REPORT AND RECOMMENDATIONS ON UNDERWATER DAMAGE

REPORT & RECOMMENDATIONS  
ON UNDERWATER DAMAGE ASSESSMENT  
PIER LIMA  
NAVAL STATION, GUANTANAMO BAY, CUBA

SEPTEMBER 1979

Re: Contract No. N624477-79-C-0387  
Inspection of Piling, Pier Lima,  
Naval Station, Guantanamo Bay,  
Cuba

FIGURE 2  
ALTERNATE PILE REPAIR  
BY INISWELL INC

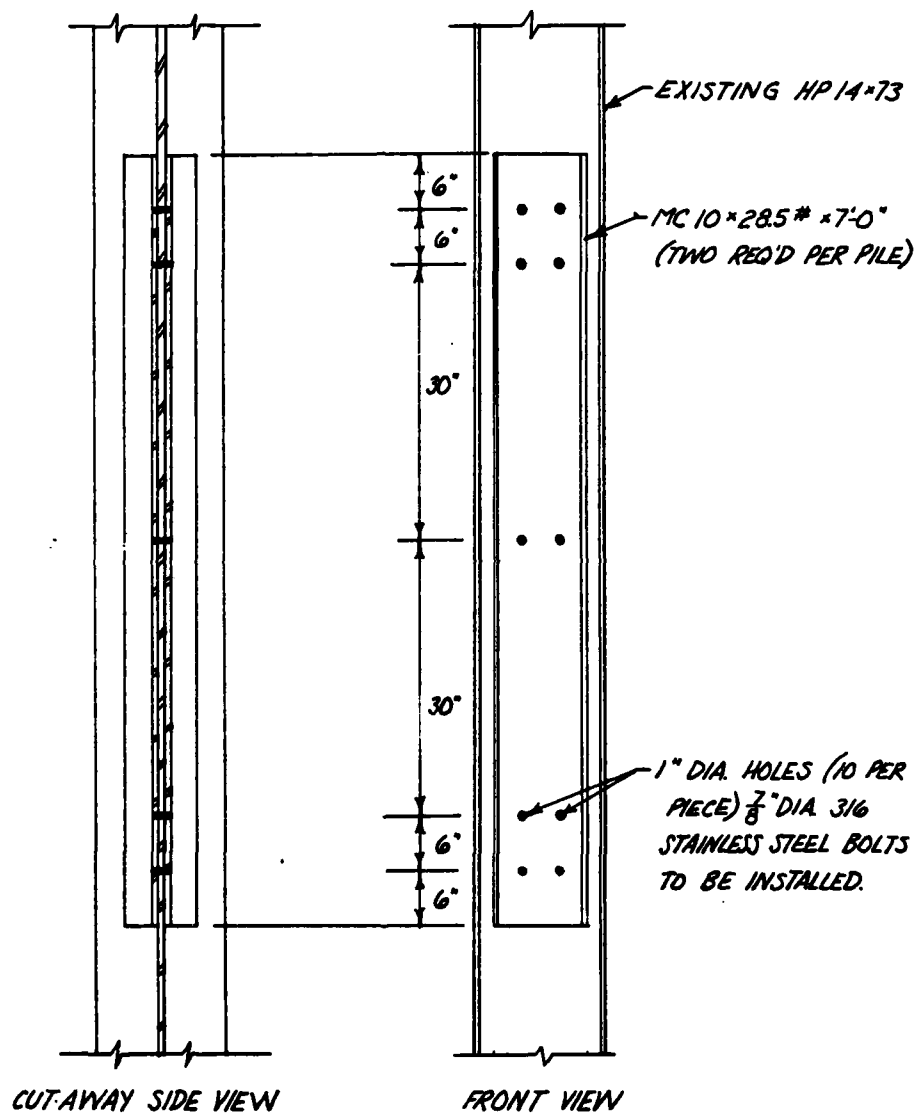
1. Page 14, line 23...delete "stainless"
2. Page 18...delete "316 stainless"
3. Page A-17, line 1...change "Fasteners"  
to "Bolts"
4. Page A-18 should have been transposed with  
page A-21 (i.e. bents 51-55 should have  
been in the beginning of the appendix).
5. Page A-25, line 1...change "BJD" to "DBJ"
6. The last two pages, the reference page  
and the bibliography page should have been  
bound between p. 23 and the Appendix 1  
title page.

1. P. 14, 3rd #, 4th line — delete the word "stainless."
2. P. 18, Fig. 2, notation for bolts, delete the words "316 stainless"
3. P. A-25 change "BJD" at top of sheet to "DBJ".
